ADDENDUM 03 SOFTBALL UPGRADES

Date: Monday, December 8, 2025

Project #: 0323.25.002

Project Name: Softball Upgrades
Vicksburg High School – 3701 Drummond St., Vicksburg, MS 39180
Warren Central High School – 1000 MS-27, Vicksburg, MS 39180

1 WALL SECTION 1
1" = 1'-0"

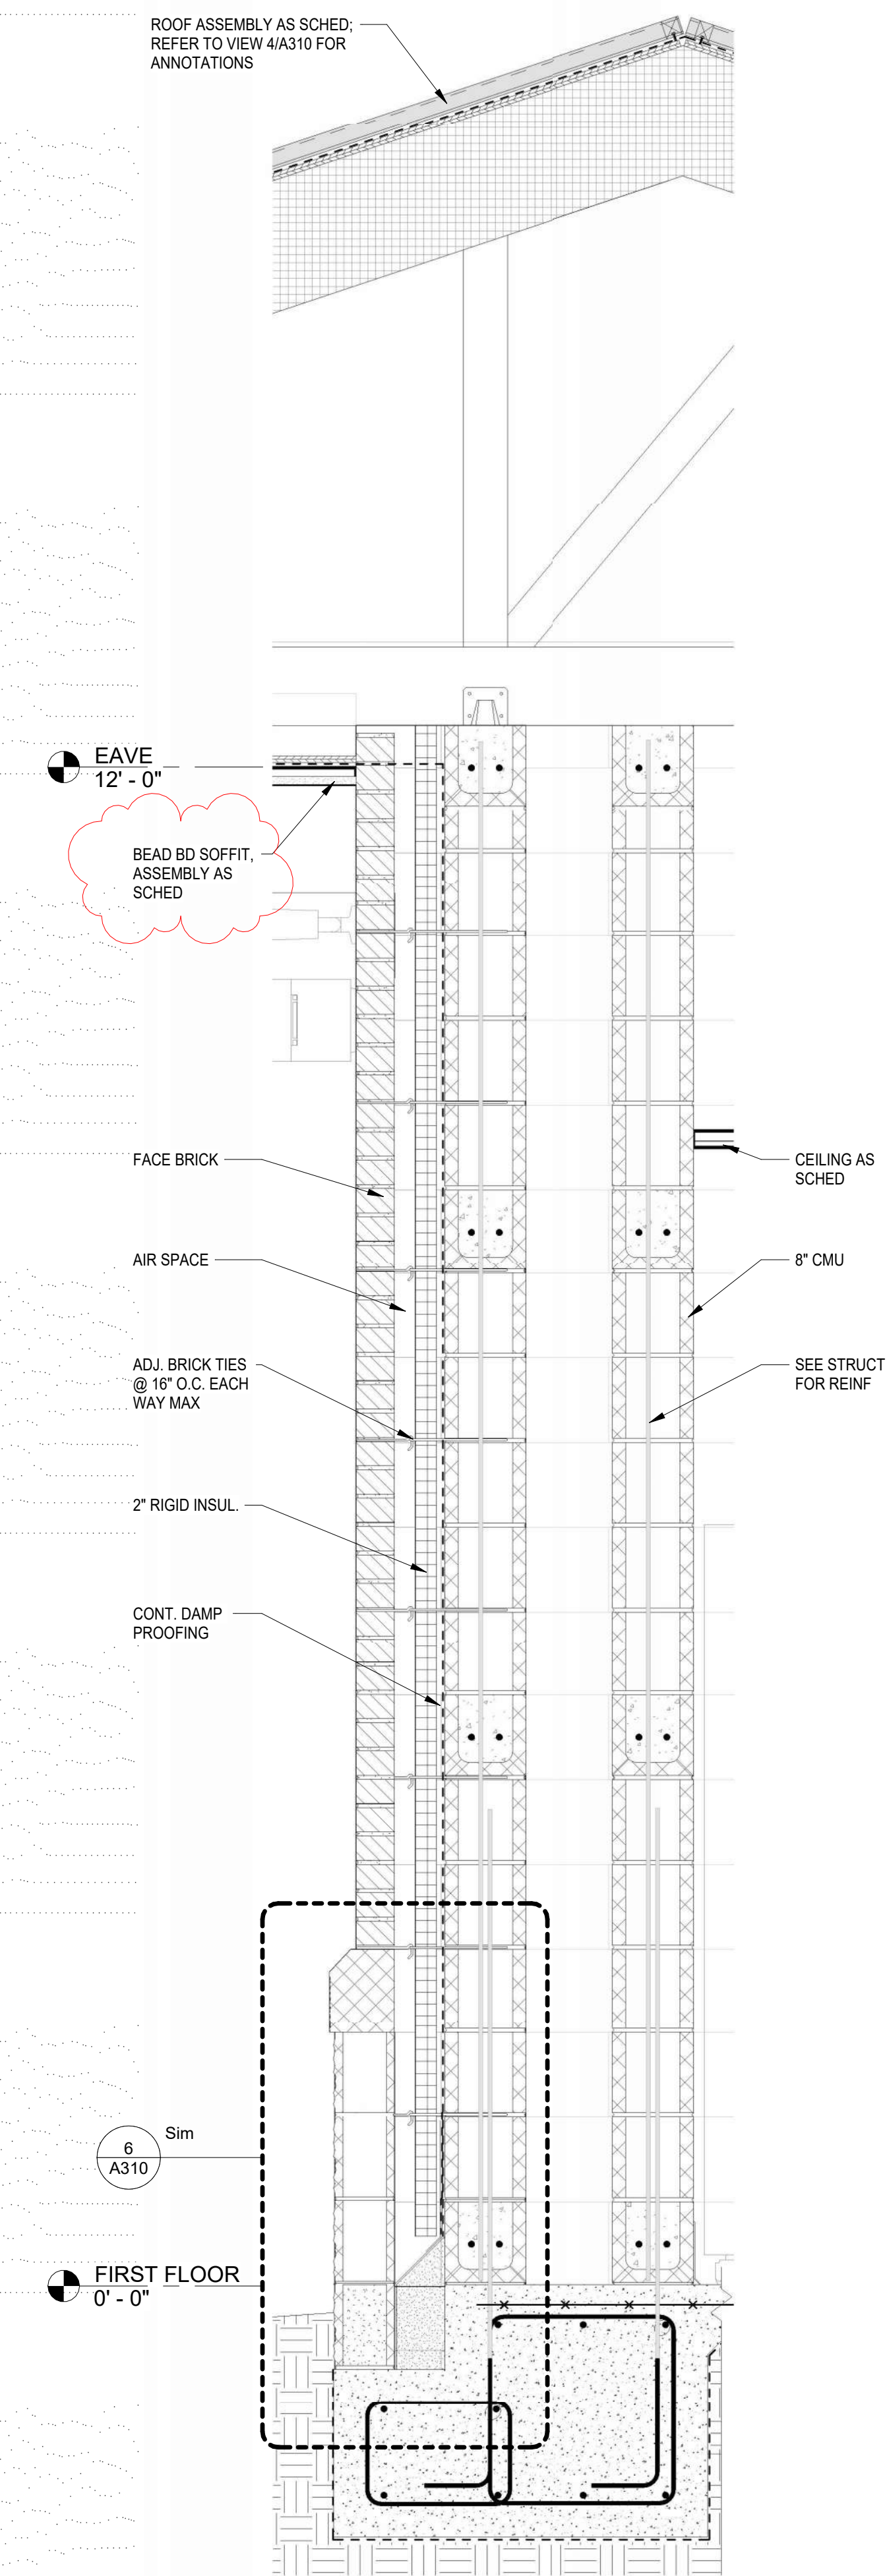
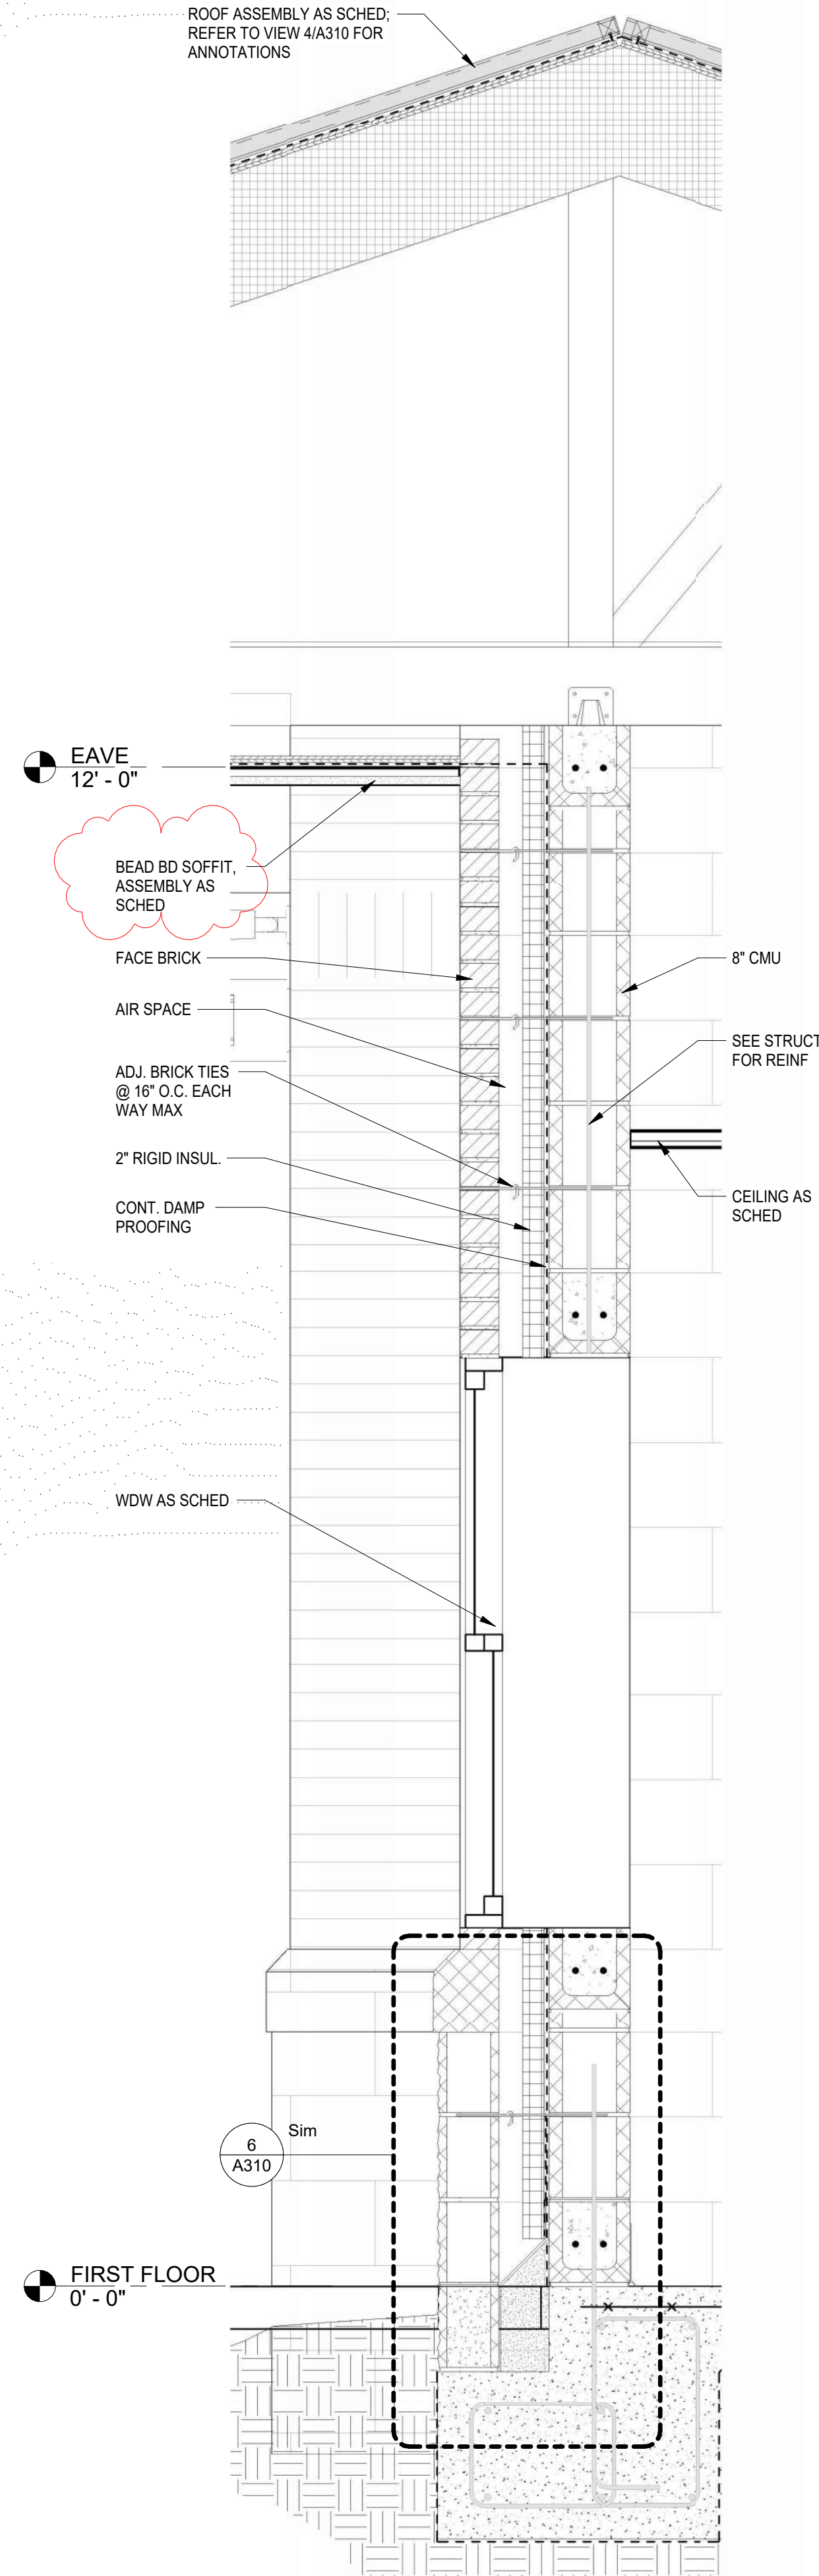
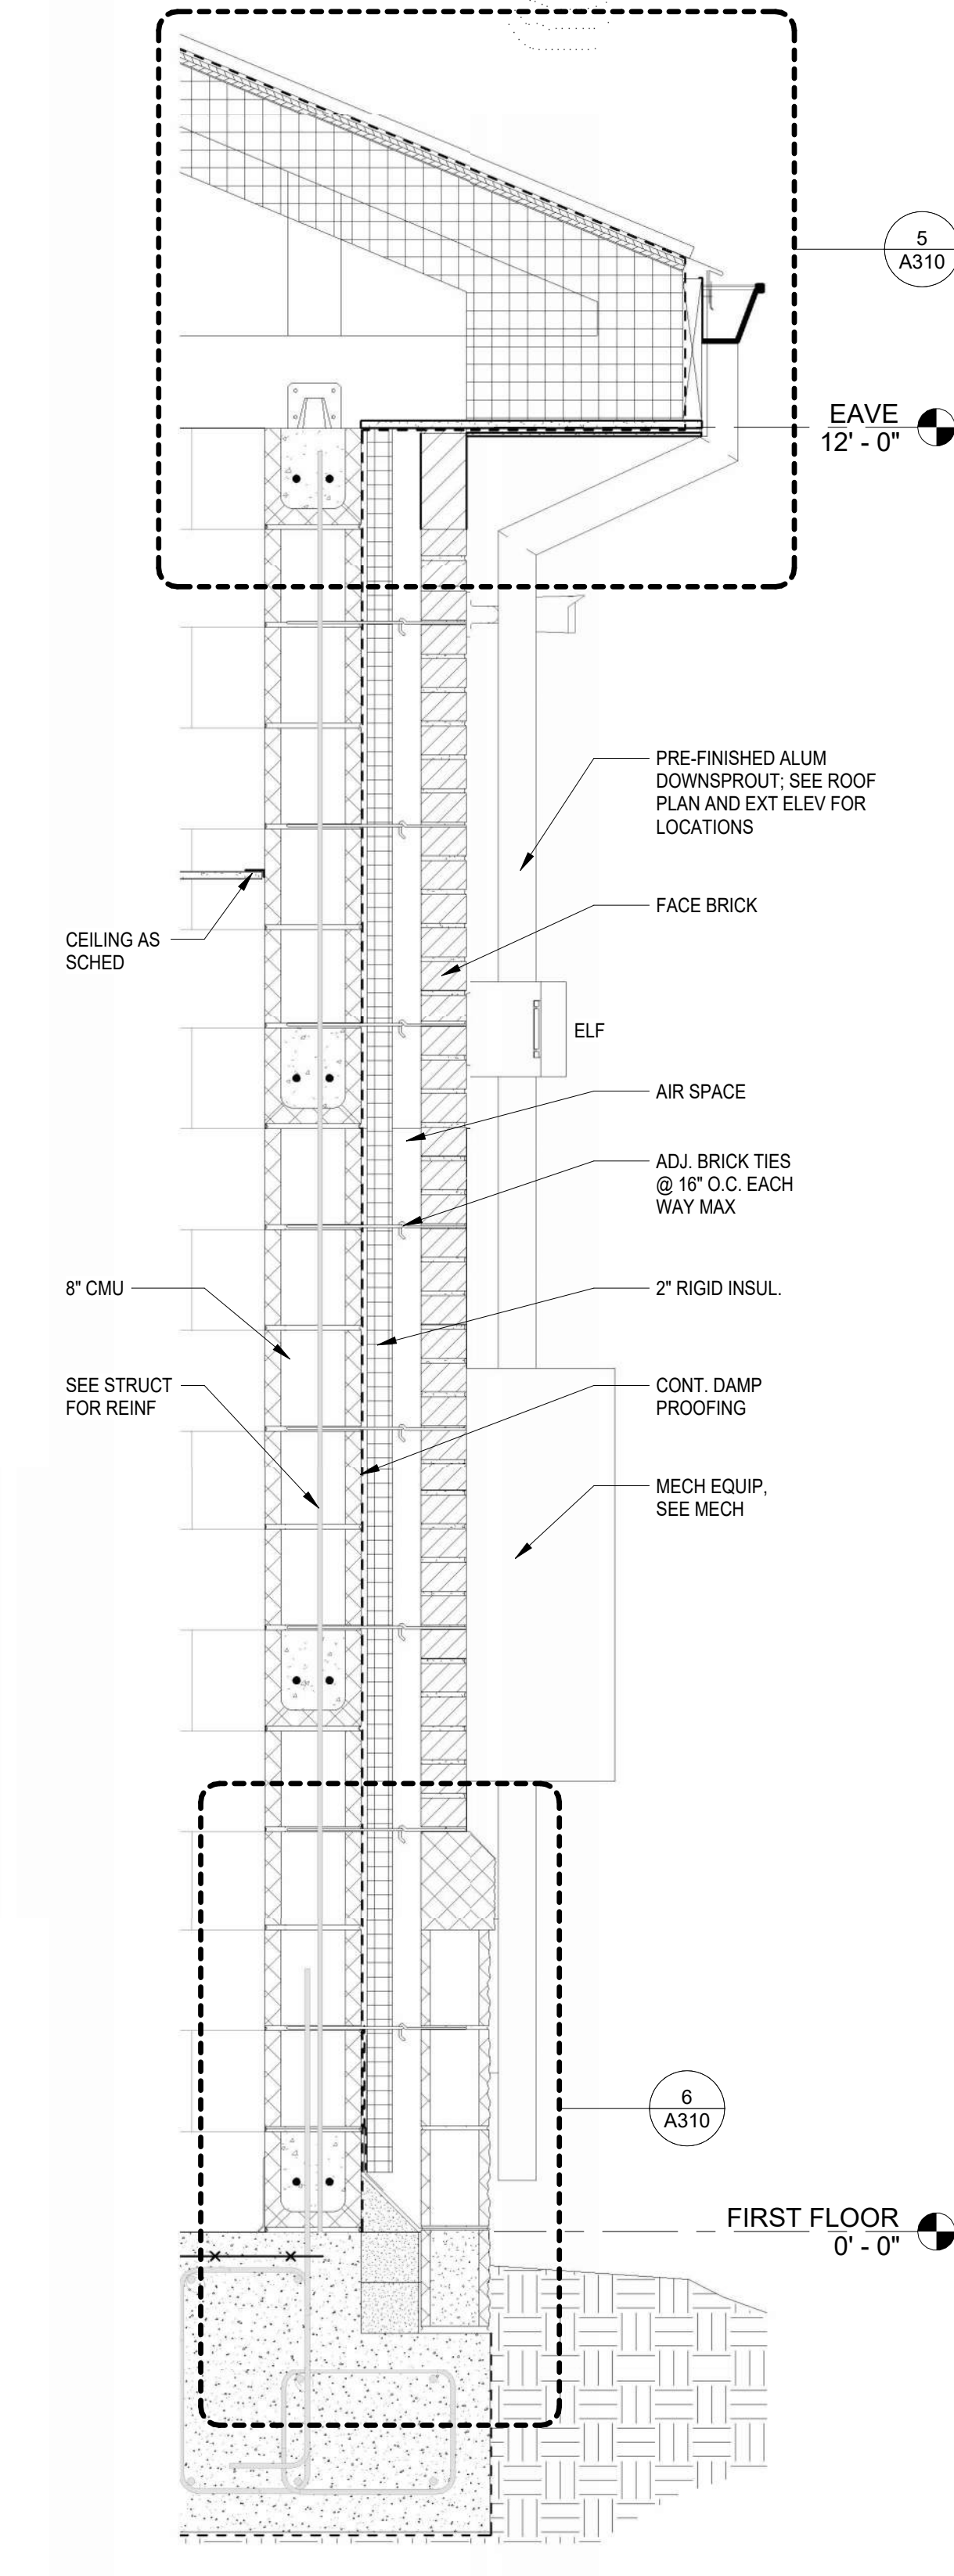
- B3. Please clarify the Soffit materials. **The Reflected ceiling plan is correct, the soffit is cementitious bead board. Details have been corrected in the attached revised drawings.**
